RENESAS TECHNICAL UPDATE

Product Category	MPU & MCU	Document No.	TN-RX*-A065A/E	Rev.	1.00
Title	Errata to RX62N and RX621 Groups User's Manual Regarding CAN Module		Information Category	Technical Notification	
Applicable Product	RX62N Group, RX621 Group	Lot No.	Reference Document	RX62N Group, RX621 Group User's Manual: Hardware Rev.1.30 (R01UH0033EJ0130)	
		All

This document describes corrections to the chapter "CAN module" in the RX62N Group, RX621 Group User's Manual: Hardware.

Figure 32.9 Transition between CAN Operating Modes

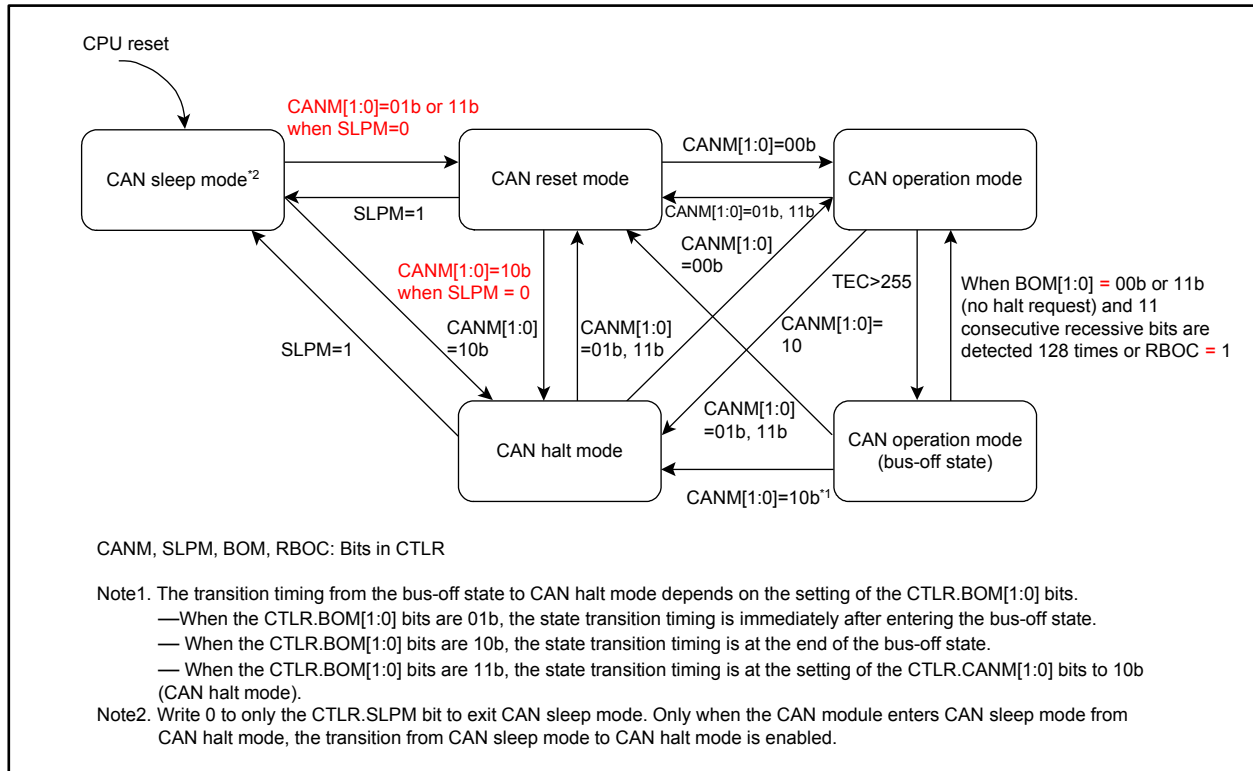
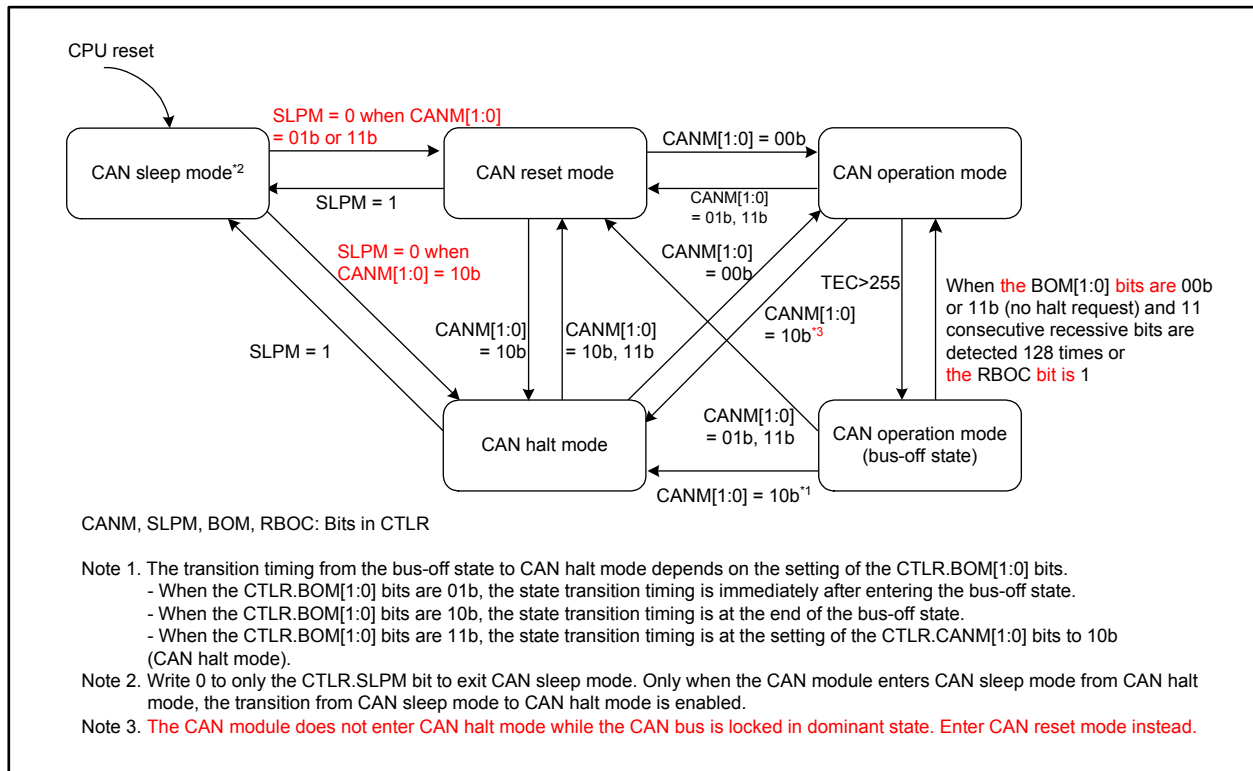
•Page 1610 of 2020
Figure 32.9 is corrected as follows:

Figure 32.9 Transition between CAN Operating Modes
